Groundwater Transfer Review Summary Form

Transfer/PA # T- 14780

Application: T-14780

Applicant Name: Kitteredge Properties LLC

T-14780 Map

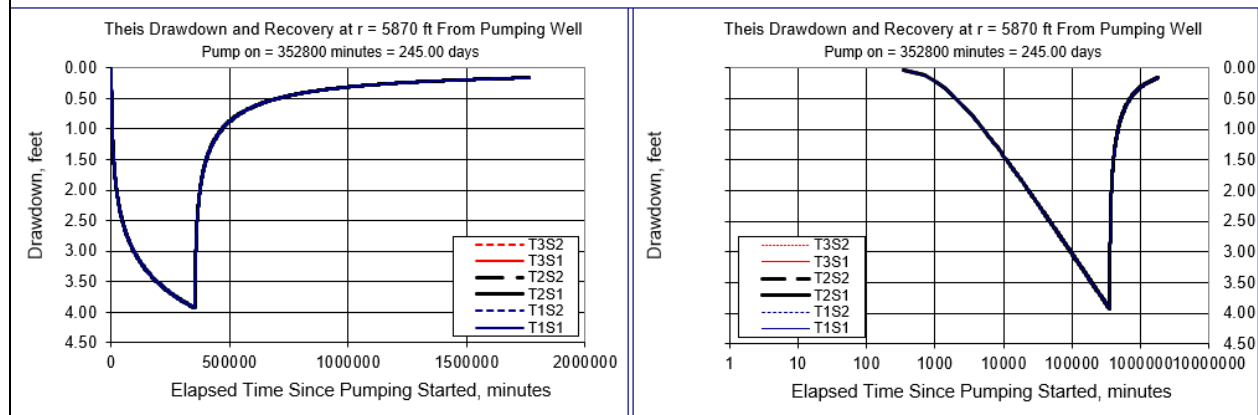
5. a) Will this proposed change, at its maximum allowed rate of use, likely result in an increase in interference with **another ground water right**?
☒ Yes ☐ No Comments: Proposed APOA is moving closer to LAKE 389, which is a POA for Certificate No. 53860. This reduced distance for the APOA will result in an increase in interference compared to pumping at the original, authorized POA.

- b) If yes, would this proposed change, at its maximum allowed rate of use, likely result in another groundwater right not receiving the water to which it is legally entitled?
☐ Yes ☒ No If yes, explain: Authorized POA (LAKE 4384) is 6580 ft away from LAKE 389 and the proposed APOA (LAKE 388) is 5870 ft from LAKE 389. Potential increase in drawdown was calculated using the Theis equation (attached below) for the projected pumping from the authorized POA, proposed APOA and the affected well using an intermediate storage coefficient of 0.001 and transmissivity of 15,000 ft²/day (McFarland and Ryals, 1991). Maximum drawdown is estimated to be 3.82 ft from the authorized POA, 3.93 ft from the proposed APOA, and 8.69 ft from the affected well which would total of 16.44 ft of drawdown in the affected well, which would not meet the standard of "substantial or undue interference".

9. Any additional comments: The proposed POU is a pivot that reported as “not in use”, but satellite imagery from 7/22/2023 suggests that this pivot was being watered in 2023. Imagery from 5/14/2020 shows an unused pivot. Based on this, water was applied to the proposed POU between 5/14/2020 and 7/22/2023. Additionally, estimated acreage of proposed POU change is approximately 7 acres larger than requested (132 acres compared to 125 acres).
